HISTORIC AND DESIGN REVIEW COMMISSION

March 15, 2017

HDRC CASE NO: 2017-108
ADDRESS: 517 E MISTLETOE
LEGAL DESCRIPTION: NCB 863 BLK LOT 18 & W 4.5 FT OF 19
ZONING: R-6
CITY COUNCIL DIST.: 1
APPLICANT: Lori Orr
OWNER: Nancy Gill, Lynn Swanson
TYPE OF WORK: Fencing
REQUEST:

720 E Mistletoe

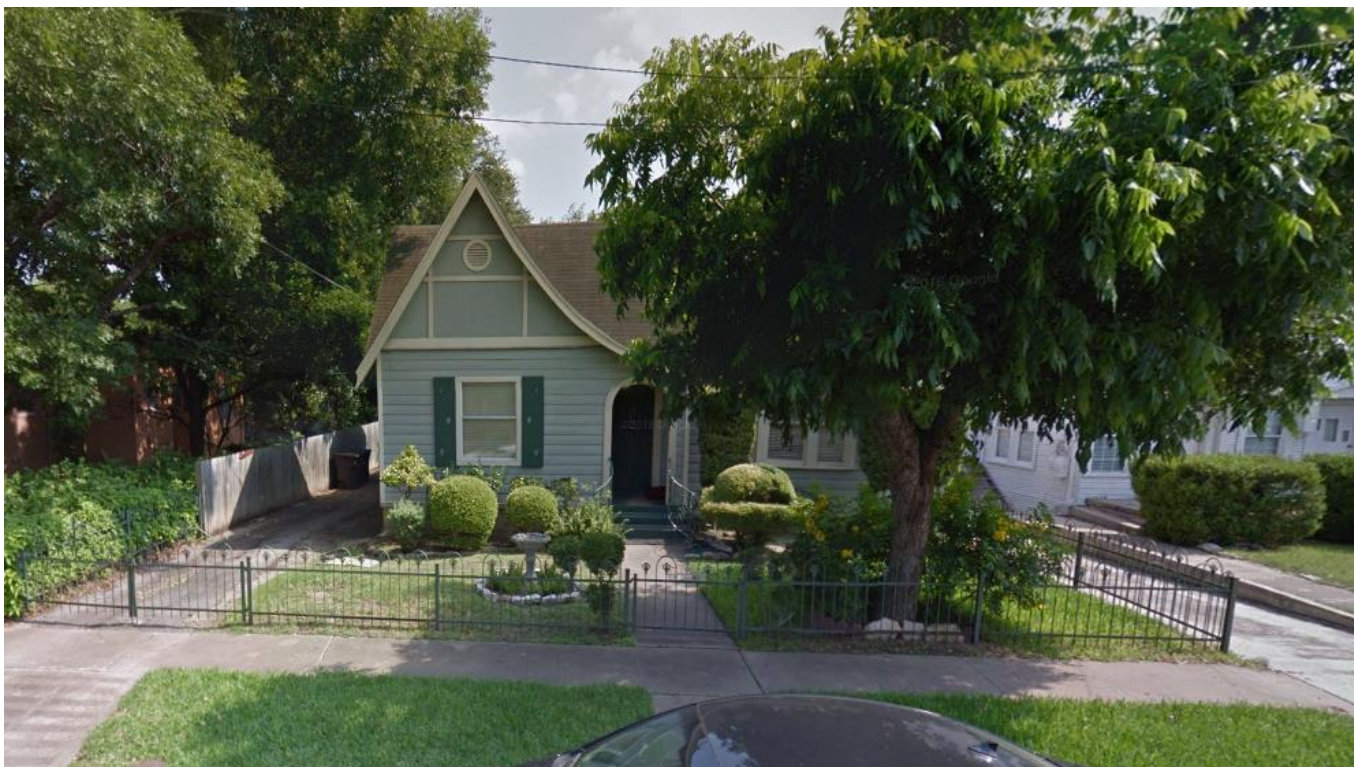
- c. According to the Historic Design Guidelines for Site Elements, the appropriateness of a front yard fence is dependent on the conditions of a specific historic district. There are several examples of fences installed in the front yard of properties in the proposed district, including wood picket style fences. However, the fences located along E Mistletoe are characteristically lower than four feet. Examples of nearby fences can be found at 305 E Mistletoe, 720 E Mistletoe, 319 E Mistletoe, 316 E Mistletoe. Staff finds the proposal to install a picket fence appropriate.

1. Staff recommends approval to remove the existing chain link fence based on finding b.
2. Staff recommends the approval of the construction of a new fence enclosing the front yard based on finding c with the stipulation that the fence is no taller than 36 inches.
